**PLANNED UNIT DEVELOPMENT****Date: December 17, 2009****DEVELOPMENT NAME**

DBM Company, LP

**LOCATION**1234 & 1248 Hillcrest Road  
(Northwest corner of Hillcrest Road and Grelot Road)**CITY COUNCIL  
DISTRICT**

Planned Unit Development Approval to allow shared access between two building sites.

# SITE PLAN

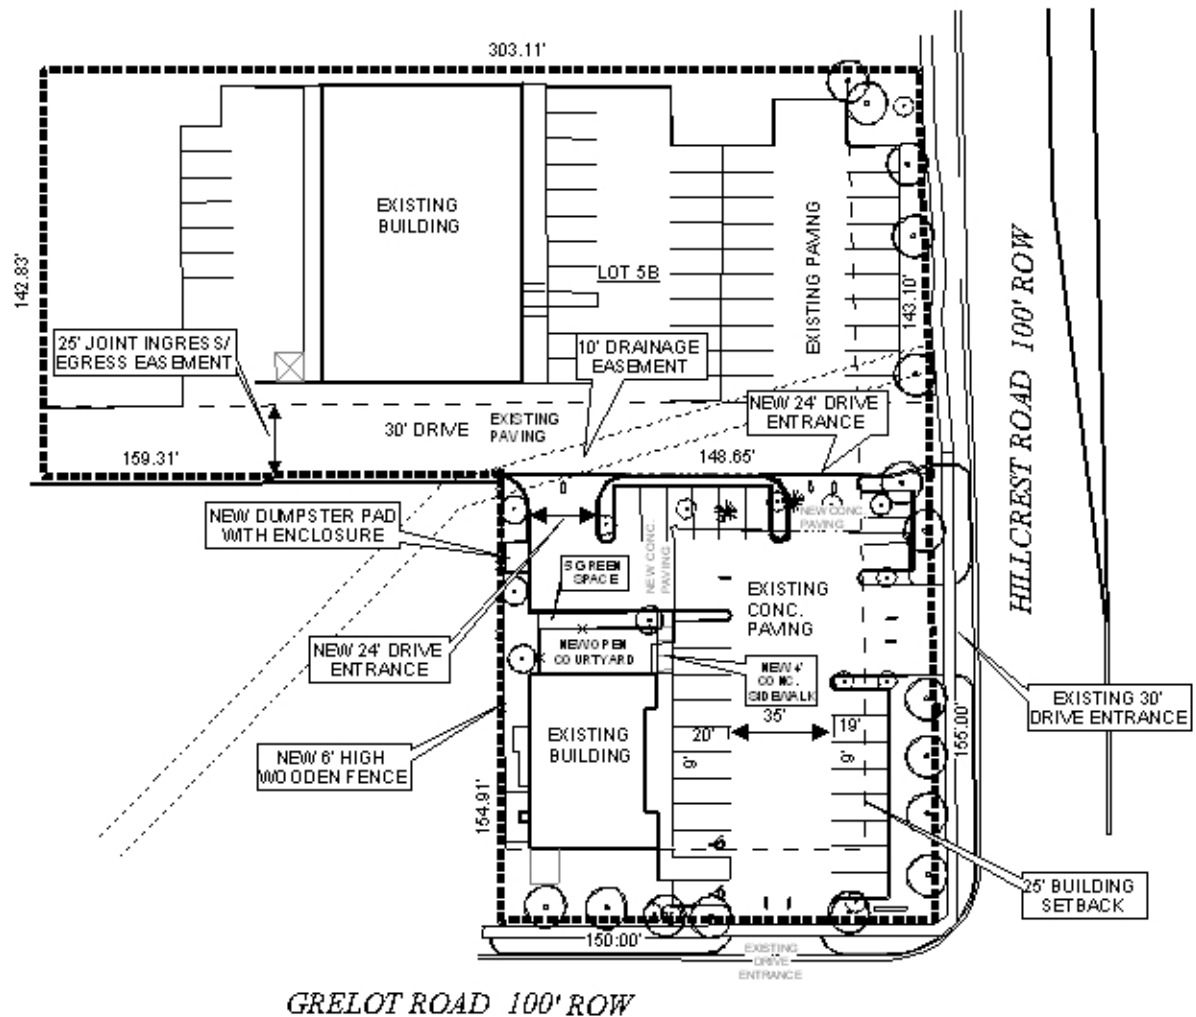
It should be noted that, while the applicant's proposal may be minor and desired, one issue must be addressed. As illustrated on the site plan, there is an existing 25' joint ingress/egress easement providing access to the property to the West of the subject site; shared access that was approved in 2006 via Planned Unit Development. Before this application can be approved, all properties sharing access must be included.

As mentioned, all proposed work is mainly limited to the Southernmost lot, which has one existing curb cut to both Hillcrest and Grelot Roads. As illustrated on the site plan, the applicant is proposing two additional curb cuts to the joint ingress/egress easement. As both Hillcrest and Grelot Roads are major streets, access management is of great concern. With that said, Planning and Traffic Engineering staff feel that the proposed number of curb cuts is extreme. At a minimum, the existing curb cut to Hillcrest Road should be removed; ideally, the Eastern curb cut to the joint ingress/egress easement should also be removed in order to provide the safest and most efficient circulation of traffic. Additionally, the applicant has not accurately delineated the existing curb cut onto Hillcrest Road for the ingress/egress easement; this should also be addressed.

It should also be noted that the proposed configuration of curb cuts will require the removal of several "protected" trees. While, the site plan appears to illustrate compliance, a new thorough review will be required at the time of permitting. Furthermore, per comments from Urban Forestry, the lot to the North should also be brought into full compliance.

It appears that proposed dumpster location is approximately one (1) foot from the West property line. Section 64-3.E.3 of the Zoning Ordinance requires a side yard setback of zero (0) **OR** five (5) feet for sites within a B-3, Community Business District; the applicant should revise the site plan accordingly.

On a minor note, the site plan illustrates the Northern property as Lot 5-A, contrary to the associated recorded plat. It should be revised to read Lot 5-B.

Based on the preceding, it is recommended that this application be held over to allow the applicant submit a revised site plan addressing the following:

- 1) Inclusion of all properties sharing access via the joint ingress/egress easement, along with the submittal of additional fees and mailing labels;
- 2) Elimination of both the Eastern curb cut onto the shared ingress/egress easement and the existing curb cut to Hillcrest Road (on the Southernmost lot);
- 3) Revision of the site plan to accurately delineate the existing curb cut onto Hillcrest Road for the joint ingress/egress easement;
- 4) Revision of the dumpster location to comply with Section 64-3.E.3 of the Zoning Ordinance; and
- 5) Revision of the site plan to label the Northern property as Lot 5-B, instead of 5-A.

# SITE PLAN ILLUSTRATING STAFF PROPOSAL

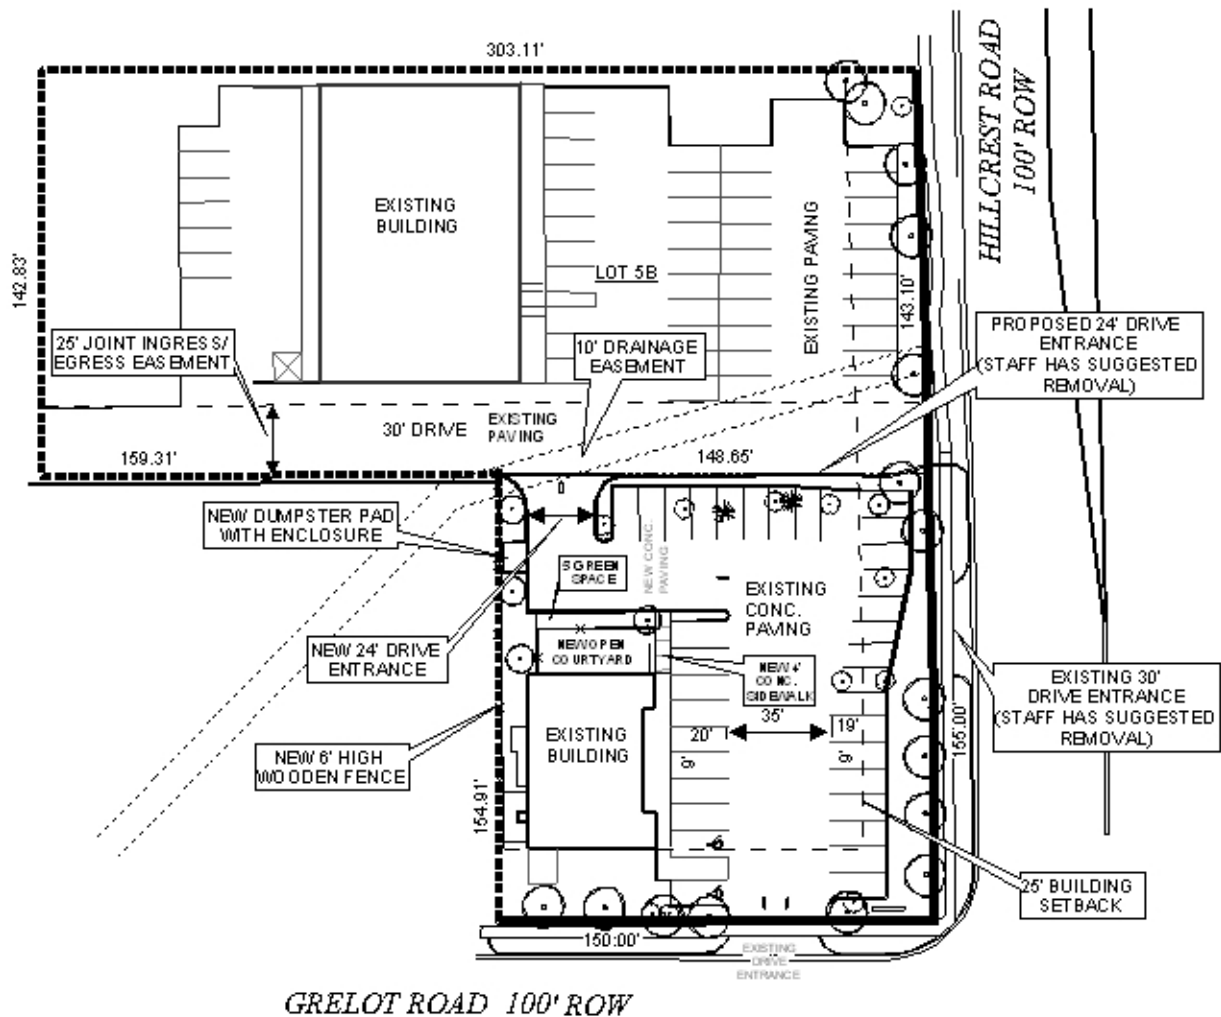
Driveway number, size, location, and design to be approved by Traffic Engineering and conform to AASHTO standards. To improve access to Hillcrest Road and to eliminate on site circulation conflicts the driveway accessing Hillcrest Road from the site should be closed and the eastern most driveway access the easement should be eliminated.
